Product / Process Change Notification

PCN No: PCN-2016-02-17

Change Title: attachable valve connectorsChange Classification: Minor MajorChange Item: Design Raw Material Packaging Firmware Others

Contact-bearer

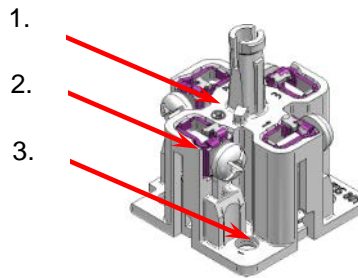
The design of the contact-bearer changed to a new shape with special cross-beam (1), rounded edges (2) and a new screw-assembly (3). This particular improvement has made to create better mechanical stability when using screws to secure cables. Due to the new shape and fitting, the assembly within the housing is more reliable, even in harsh conditions like shock and vibration.

PCB Technology and connection (double PressFit)

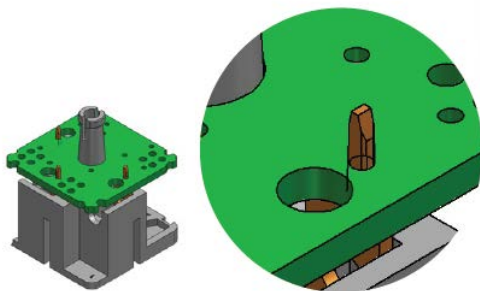
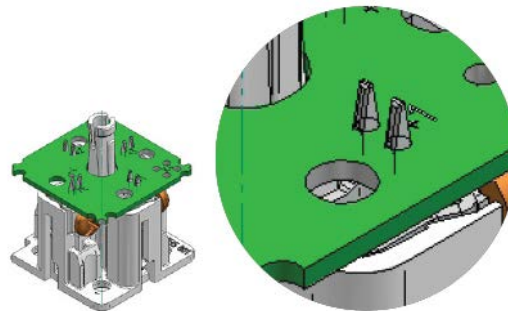
In order to match the latest PCB technology for all our circuits, Belden redesigned the PCB-assembling and the connection to the contact-bearer.

To guarantee a better vibration-behavior and reliability of contact resistance and joints, the design has been upgraded to a double PressFit connection.

Gaskets:

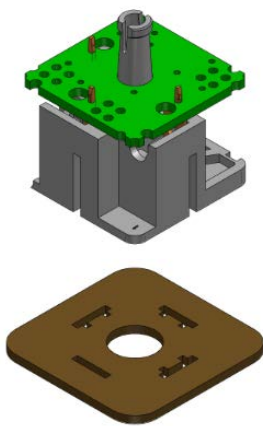
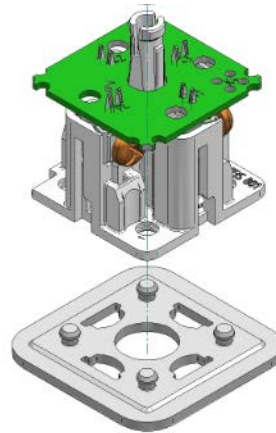
To guarantee that gaskets in field remain securely fastened, special captive gaskets have been designed. Now they can be clipped into the contact-bearer directly. The old gaskets are still available and interchangeable with the new contact-bearer.

The new gaskets can be ordered in EPDM (735-677-004) and NBR (735-667-003) separately.

Improvements at a glance:

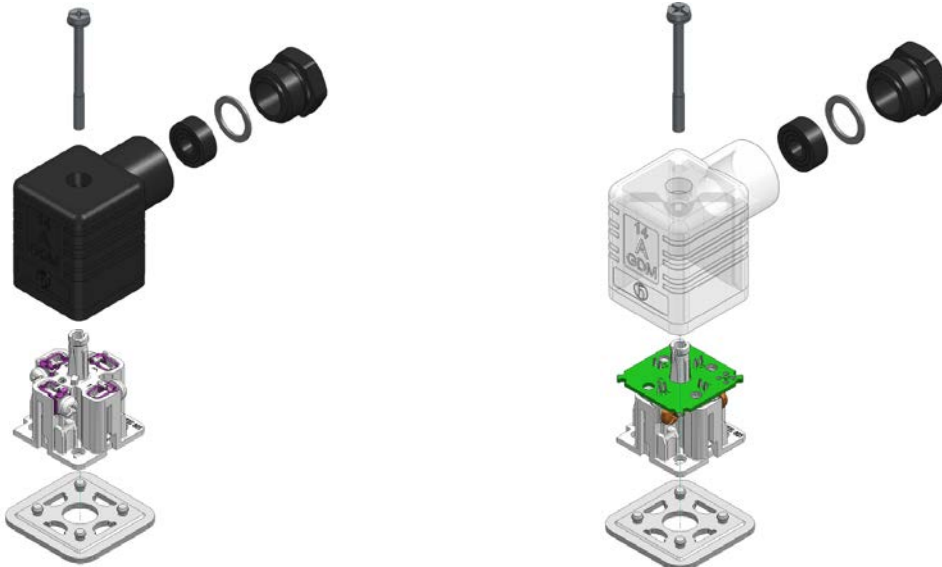
- Highly resistant against mechanical vibration and shock
- New screw assembly
- Latest PCB and connection technology
- Availability with captive gaskets

Kontaktträger

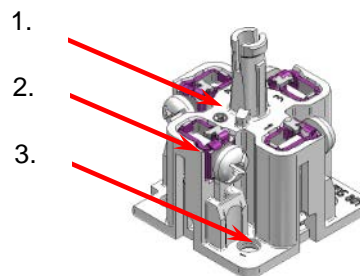
Das Design des Kontaktträgers wurde um neue Verstrebungen (1), abgerundete Kanten (2) und ein neuer Schrauben-Aufbau (3) geändert. Diese Verbesserungen dienen der besseren mechanischen Stabilität beim Kontaktieren mit Leitungen. Aufgrund der neuen Form und Passform ist die Baugruppe innerhalb des Gehäuses zuverlässiger und leichter zu montieren. Die Zuverlässigkeit zeigt sich besonders in rauen Umgebungen, bei denen Schock und Vibrationen eine Rolle spielen.

Leiterplatten-Technologie und -Kontaktierung (double PressFit)

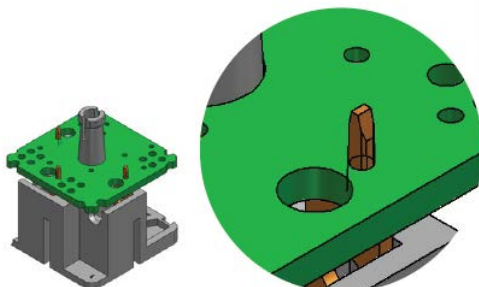
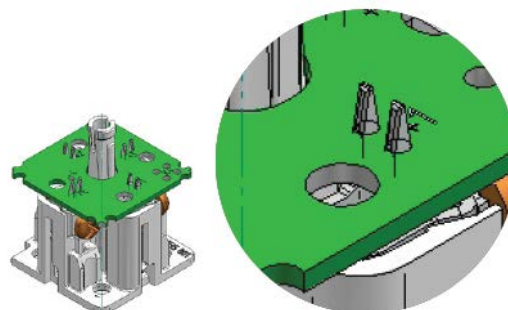
Um auch die aktuellste Leiterplatten-Technologie für alle Schutzbeschaltungen zu nutzen, hat Belden eine Neugestaltung der Leiterplatten-Baugruppe und der Kontaktierung zum Kontaktträger durchgeführt.

Damit hierbei ein besseres Vibrationsverhalten und Zuverlässigkeit des Kontaktwiderstandes und der Verbindungsstelle gewährleistet werden kann, ist ein doppelter Press-Kontakt (double PressFit) zum Einsatz gekommen.

Dichtungen:

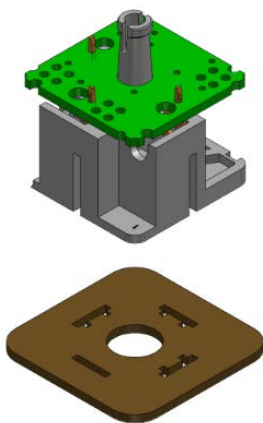
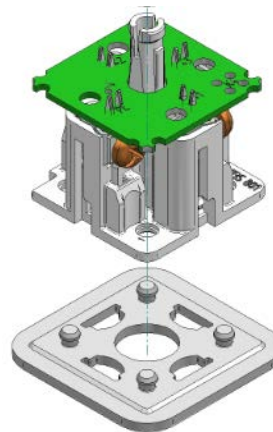
Damit ein Halten der Dichtungen im Feld gewährleistet werden kann, kommen neue „unverlierbare“ Dichtungen zum Einsatz. Diese werden nun direkt in den Kontakträger geklemmt, wobei auch die alten Dichtungen nach wie vor verfügbar sind und mit dem neuen Kontakträger kompatibel sind. Die neuen Versionen können in EPDM (735-677-004) und NBR (735-667-003) separat bestellt werden.

Verbesserungen auf einen Blick:

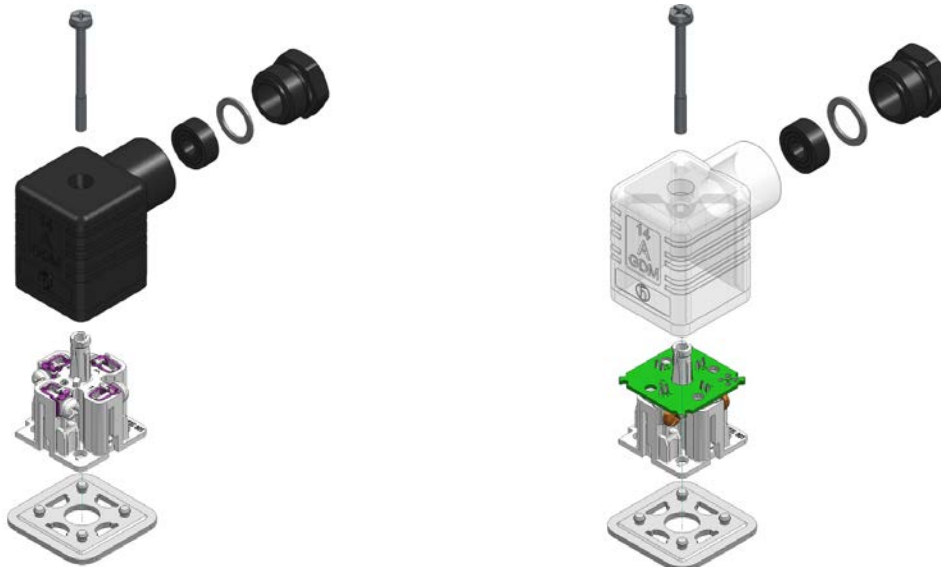
- Sehr widerstandsfähig gegen mechanische Vibration und Schock
- neuer Schrauben-Aufbau
- aktuellste Leiterplatten-Technologie und Kontaktierung
- Verfügbarkeit mit klemmbarer Dichtung
